Final Decision

Planning Commission

File number(s): MOC 23-03 to CU 22-02, DR 22-11, & VAR 22-09

Public Works Comments
CU 22-02, DR 22-11, & VAR 22-09
Townsend Farms
(960 Young Street)
January 18, 2023

Exhibit CU3b(2)-1: Trees 1-3 from Sheet C007

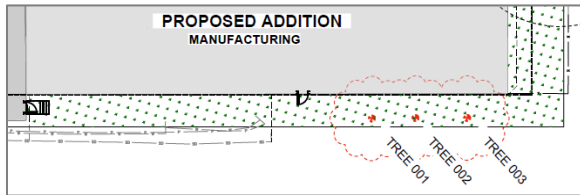
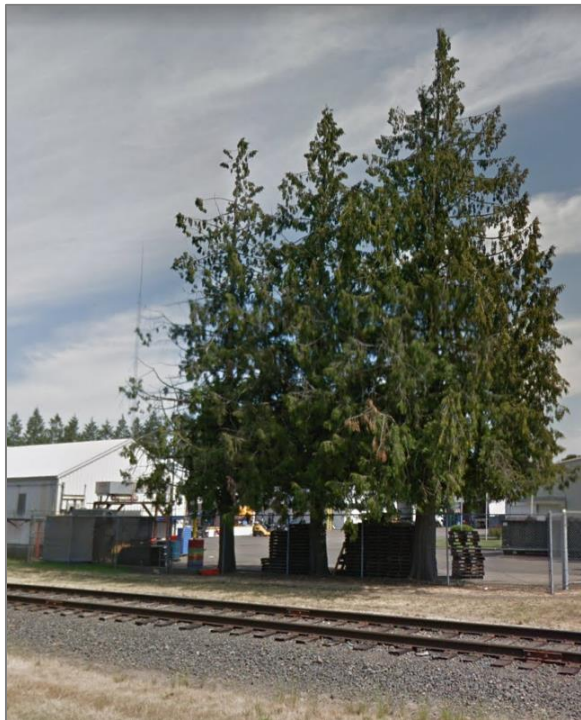
- a. ROW: n/a.
- b. On-site:
 - (1) The developer shall pay a mitigation fee for Trees 16 & 17, which Sheet C007 illustrated as proposed to be removed, per Attachment 203.
 - (2) Based on WDO 5.03.01B.3c5), the developer shall replace Trees 1-3 proposed to be removed with two coniferous/evergreen trees at minimum size at planting per Table 3.06B and in the same 10-foot wide easterly south yard along the building addition.

Exhibit V1a-1 Sheet C004 Fire apparatus roads

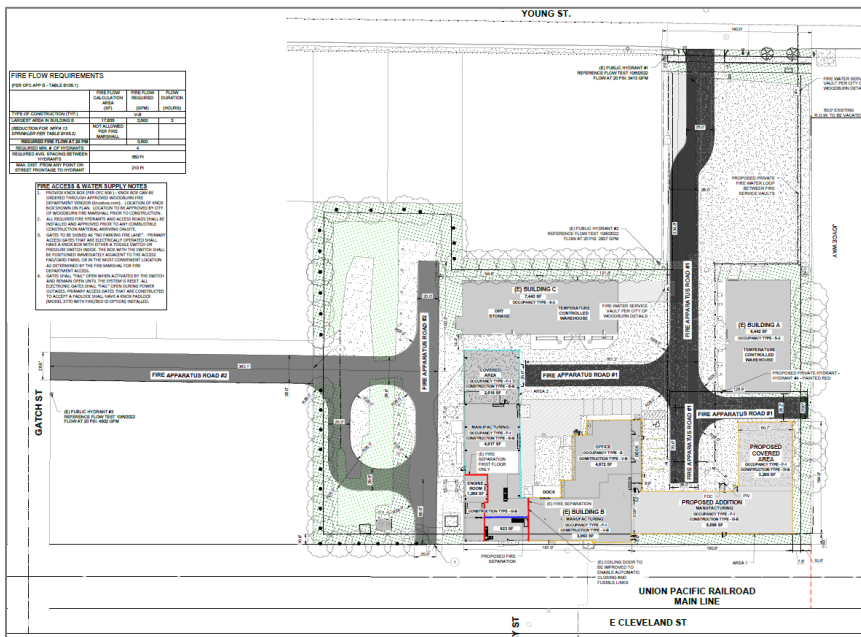
V1. Joyce Way west half-street improvements variance: Fire apparatus road #1: The request to vary from Woodburn Development Ordinance (WDO) 3.01.03A & C.1, Figure 3.01A, 3.01.04B.1, and Figure 3.01G regarding the unnamed paper street right-of-way (ROW) at the east that City staff terms “Joyce Way” is approved, but with provisions as follows and, where conflicting with Condition G4, superseding:

- a. Objective: The objective of this condition is to have Townsend Farms improve or pay for improved fire access as follows: Upon either DR 22-06 1030 Young Street residences development or any redevelopment of that property that constructs a Joyce Way east half-street similar to how land use review Sheet PP-2 illustrated providing access to 1030 Young Street, then Townsend Farms shall per Woodburn Fire District (WFD) administration of the Oregon Fire Code (OFC) improve the gap between the half-street and the east dead-end of fire apparatus road #1 as CU 22-02 land use review Sheet C004 illustrated it and install a gate and emergency key box.

- b. Due date: Per the WFD Fire Marshal, yet no later than before issuance of the first certificate of occupancy (C of O) for a 1030 Young Street redevelopment. The City delegates administration of this fire access condition to the WFD Fire Marshal, and after the developer and the Fire Marshal implement the condition, the developer shall submit to City staff documentation that the WFD considers the condition met, whether through improvement or fee in-lieu.

- e. The developer shall revise the site plans prior to building permit issuance.
